UNITED STATES PATENT AND TRADEMARK OFFICE

Office Action Summary

10/576,521

DETAILED ACTION

Fig. 1 of Werner et al.

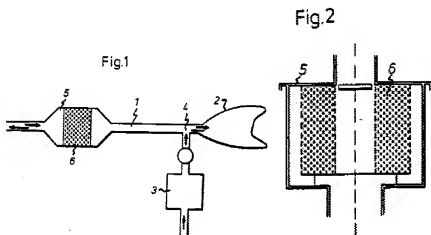
In regards to claim 4, modified Psaros et al. teaches a device according to claim 1, however is silent as to the housing is in the form of a box having a height that is smaller than a smallest extension thereof transverse to the height, wherein the absorption body is plate-shaped and is in the active position thereof substantially perpendicular to the height, and wherein each opening has a flow direction that is substantially parallel to the absorption body.

Werner et al. teaches an apparatus for reuse of anaesthetics with substantially similar structure as Psaros et al. Werner et al. teaches a adsorption filter (5) with

adsorption material (6) in the box shape as claimed. (see Werner et al.: Fig. 1) The absorption body is plate-shaped and perpendicular to the height. (See Fig. 2, note that height is in the horizontal direction) It would have been obvious to one of ordinary skill in the art at the time of the invention to substitute the filter housing of Psaros et al. in view of Werner et al, because Werner et al. states that filter (5) allows for "reuse of anesthetics by which it is possible, at reasonable costs, to utilize high-priced anesthetics" (col. 1 ln. 60).

In regards to claim 5, modified Psaros et al. teaches a device according to claim 1, however is silent to the two flow paths are concentrically arranged in relation to each other. Werner et al. teaches an alternative setup of the adsorption filter (5) in Fig. 2. Substituting this arrangement of the filter in modified Psaros et al. with the disc valve taught by Hayek would arrange the two flow paths concentrically as claimed. It would have been obvious to one of ordinary skill in the art at the time of the invention to modify the arrangement of the filter inside the housing of modified Psaros et al. in view of Werner et al., because Werner et al. states that the arrangement taught allows "ingoing and outgoing gas flow is compelled to pass through the adsorption material" (col. 2 ln. 46).

In regards to claim 6, modified Psaros et al. teaches a device according to claim 5, wherein the absorption body is arranged in the flow path through the housing. The filter arrangement taught by Werner et al. is in the flow path through the housing as

claimed. (see Werner et al. Fig. 2) It would have been obvious to one of ordinary skill in the art at the time of the invention to modify the arrangement of the filter inside the housing of modified Psaros et al. in view of Werner et al., because Werner et al. states that the arrangement taught allows "ingoing and outgoing gas flow is compelled to pass through the adsorption material" (col. 2 ln. 46).
